Office Action Summary	Application No. 10/598,531	Applicant(s) GOLDBACH ET AL.	
	Examiner Madison L. Wright	Art Unit 3781

DETAILED ACTION

This figure, now referred to as Babcock annotated Fig. 3, used for the rejection of claim 6 has been replicated below, and the Examiner has added reference points for ease of explanation, and said reference points will be used for the rejection of claim 6 below.

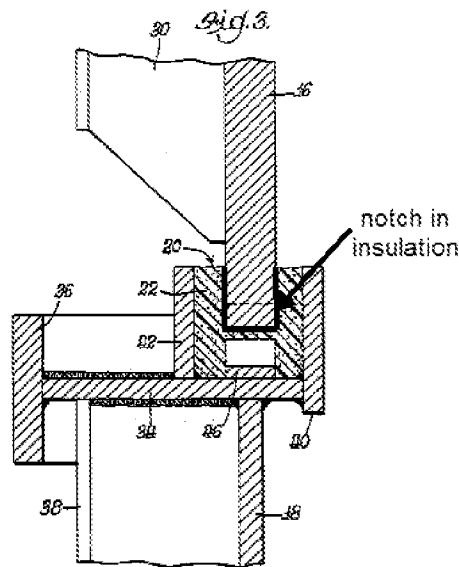
As to claim 6, Babcock teaches the support assembly according to claim 4 wherein said load bearing insulation (hardenable material 22) includes a notch (notch, Babcock annotated Fig. 3) conforming to the shape of a securing structure projecting outwardly from the tank wall or top (Fig. 3).
